RE: Energy Safety NOV ID: CAD\_PGE\_CYA\_20250325\_1204

Notice of Violation: Government Code § 15475.1 and the California Code of Regulations, Title 14, Division 17 § 29302(b)(2)

Initiative 8.1.2.5.1 – Traditional Overhead Hardening (Transmission Conductor), Utility Initiative GH-06:

Image 1: Drone photos from December 2024 show the two shunt splices installed on the span of 11/229-11/230, but they are closer to structure 011/230 (as pictured).

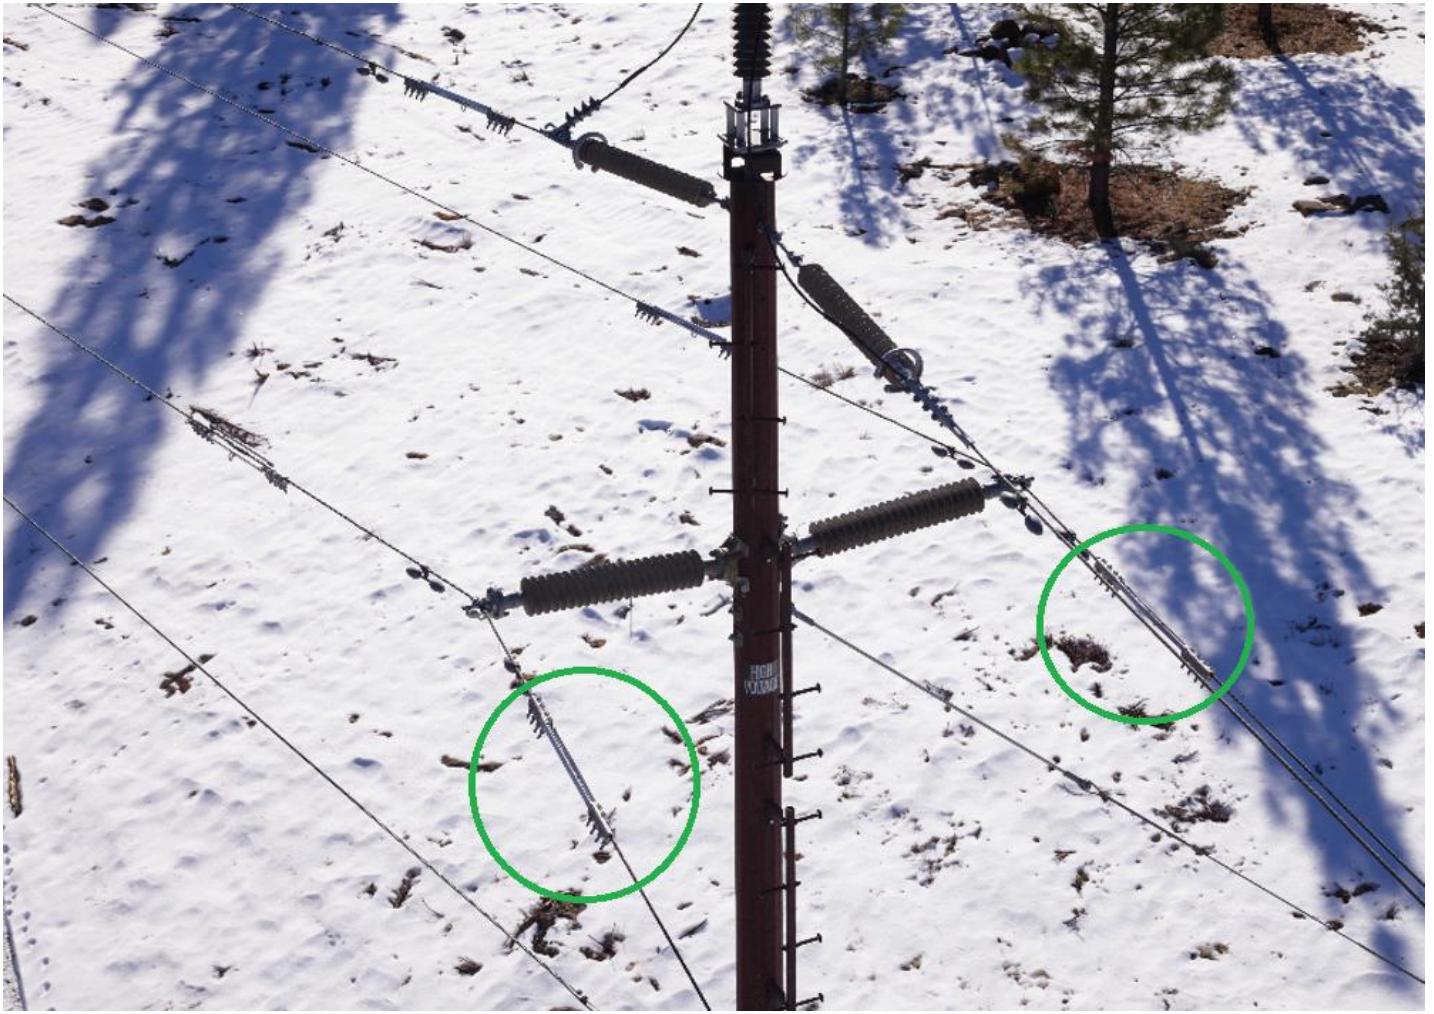
*Violation 1. Energy Safety observed that in implementing 2024 WMP initiative 8.1.2.5.1 - Traditional Overhead Hardening - Transmission Conductor, PG&E failed to complete work on pole ID 011/229, Grid Hardening ID 74057080-3, at coordinates 40.828823, -121.381875. Energy Safety considers this completeness violation to be in the Minor risk category.*

PG&E respectfully disagrees with Energy Safety's alleged NOV conclusion for Hat Creek #1-Westwood structure 011/229, which we understand to refer to the span of conductor between 011/229 and 011/230. We understand that upon observation, an assumption can be made that because two of the splices are closer to structure 011/230, they are a part of structure 011/230. As shown in "*Image 2*" below, in the engineering drawing 233949 revision 2, found within the as-built previously provided to Energy Safety, there are three splices between structure 011/229 and 011/230. Two of the three splices are shunted and positioned closer in proximity to 011/230. The other remaining splice is not shunted and is in closer proximity to 011/229. PG&E has confirmed this in the field, as is shown in "*Image 1*" below:

The splice depicted in the NOV letter 'Item1IA1Img2: Splice, is a moused splice and does not represent the splice that was designated for replacement under the 2024 grid hardening initiative.
